Access Compliance Report

Public Rights-of-Way

(Curb Ramps)

Intersection ID: 42368	Main Street: FAIRVISTA_DR	Cross Street: HIGHLAND_CREEK_PY	Location: NW
ADA ID: 104E99AA8EDF	Ramp Type: PerpDiag	Initial Pass/Fail: Fail	Overall Compliance: No
			Severity Score: 13.75

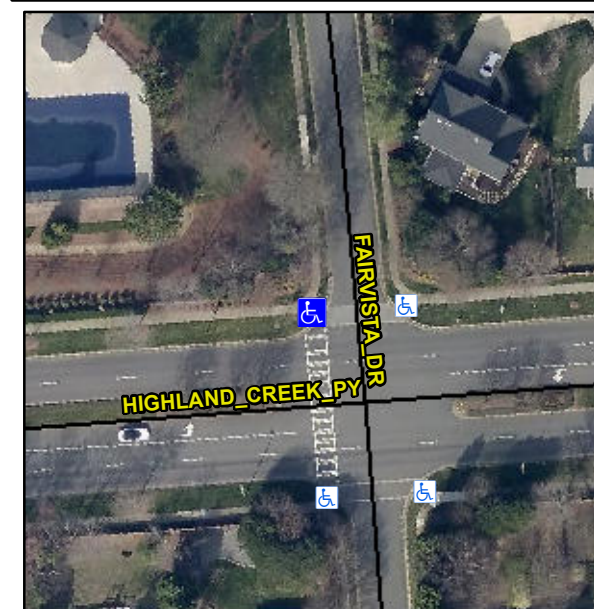
R304.2.2, R304.5.3

Compliance	Description	Data	Compliance	Description	Data
N/A	Ramp Length (in)	72.0	No	Ramp Slope (%)	10.3
Yes	Ramp Width (in)	48.0	No	Ramp XSlope (%)	3.4
N/A	Flare Type LT	N/A	N/A	Flare Type RT	N/A
N/A	Flare Slope LT (%)	N/A	N/A	Flare Slope RT (%)	N/A
N/A	Flare Traversable LT?	N/A	N/A	Flare Traversable RT?	N/A
N/A	Landing Length (in)	N/A	N/A	DWS Provided?	N/A
N/A	Landing Width (in)	N/A	N/A	DWS Contrast?	N/A
N/A	Landing Slope (%)	N/A	N/A	DWS Length (in)	N/A
N/A	Landing X Slope (%)	N/A	N/A	DWS Full Width?	N/A
N/A	Landing Curb? (Y/N)	N/A	N/A	DWS Offset (in)	N/A
N/A	Shared Landing?	N/A			
N/A	Gutter Ponding?	N/A	N/A	Gutter Slope (%)	N/A
N/A	Gutter Lip Ht (in)	N/A	N/A	Gutter X Slope (%)	N/A
N/A	Painted X Walk1?	Yes	N/A	Painted X Walk2?	Yes
	X Walk 1 Direction	To S		X Walk 2 Direction	To E
N/A	X Walk 1 Width (in)	118.0	N/A	X Walk 2 Width (in)	98.0
	X Walk 1 Slope (%)	6.9		X Walk 2 Slope (%)	3.1
	X Walk 1 X Slope (%)	0.5		X Walk 2 X Slope (%)	4.1

N/A	Ramp inside XWalk1?	Yes	N/A	Ramp inside XWalk2?	Yes
	Road Slope (%)	5.0	N/A	Clear Space?	N/A
	Road X Slope (%)	7.8	N/A	Clear Space to XWalk (in)	N/A
N/A	Any Obstructions?	N/A	N/A	Storm Grate/Utility Hazard?	N/A
	Obstruction Type			Storm Grate/Utility Type	
		N/A			N/A
		Yes		Surface Condition? (G/P)	Good

Remove & Replace Curb Ramp With Two New Directional Ramps or Equivalent.
